**Old Roosevelt Field Contaminated Groundwater Area Site
Remedial Action (RA)
Garden City, New York
Field Change Notification (FCN)**

Request No.: RA-04

FCN Title: Revised Southern Extraction Well Screen Intervals

*Subject: Old Roosevelt Field Southern Extraction Well Installation
Well Screen Design Recommendations*

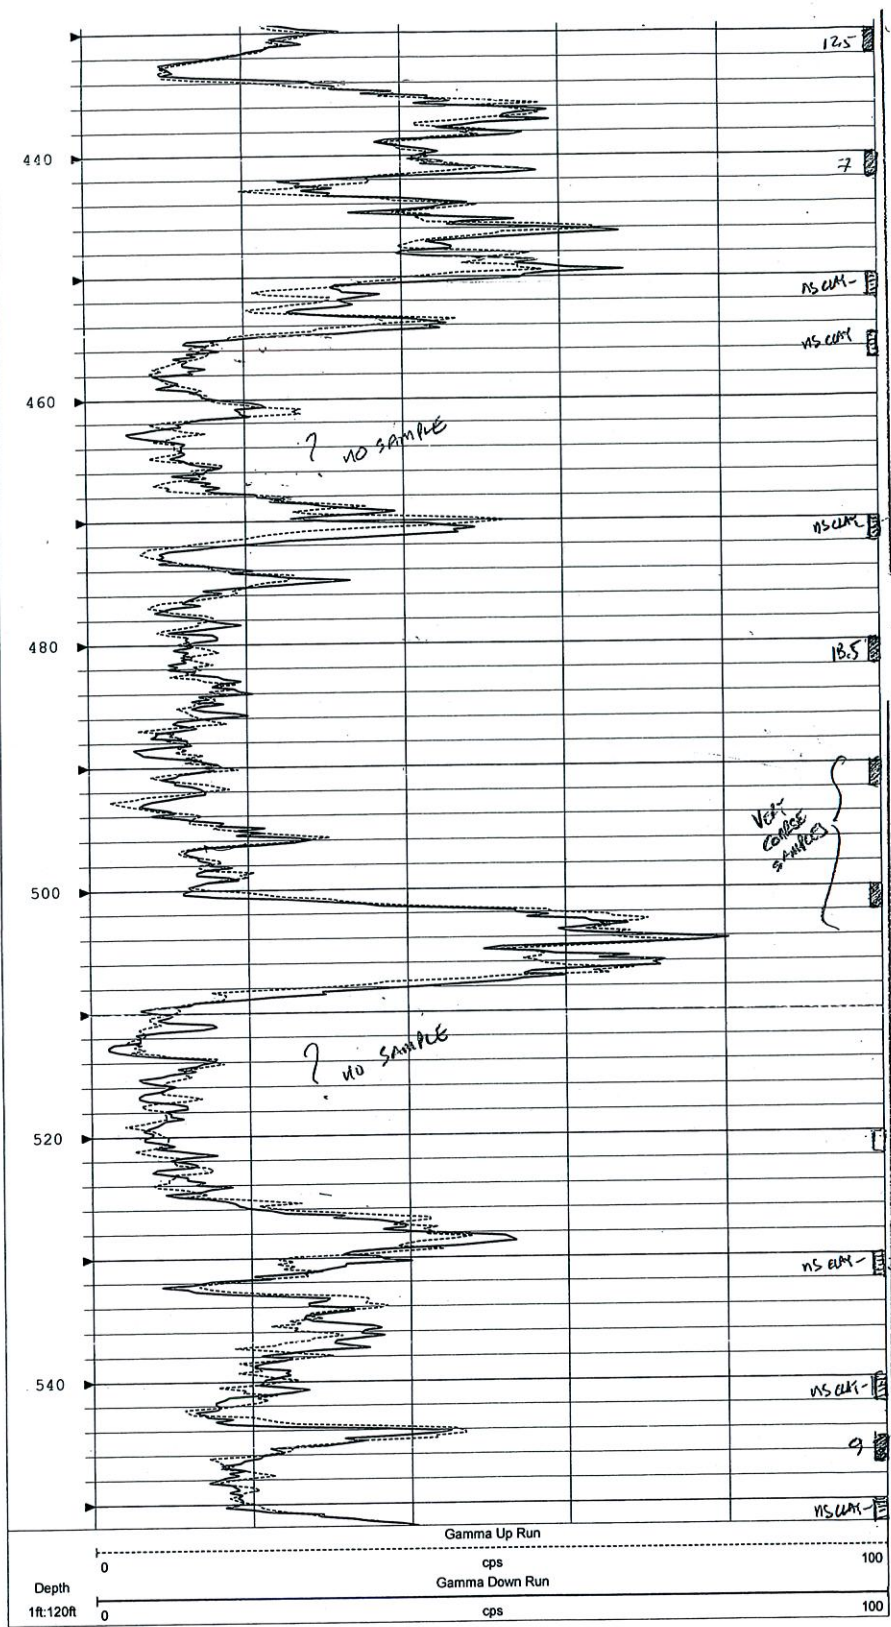
SHALLOW WELL
SCREEN 360'-400'
GRAVEL 10% SILICA
FIELD #1
SCREEN 0.075 SLOT

MIDDLE WELL
 SCREEN 41A-A34
 PLANE A34-A57
 SCREEN 457-A67
 GRAVEL - U.S. SILICA
 FILTER #0
 SCREEN 0.020 SLOT

DEEP WELL
 SCREEN 480-500
 PLANE 500-510
 SCREEN 510-525
 GRAVEL U.S. SILICA
 FILTER #1
 SCREEN 0.020 SLOT
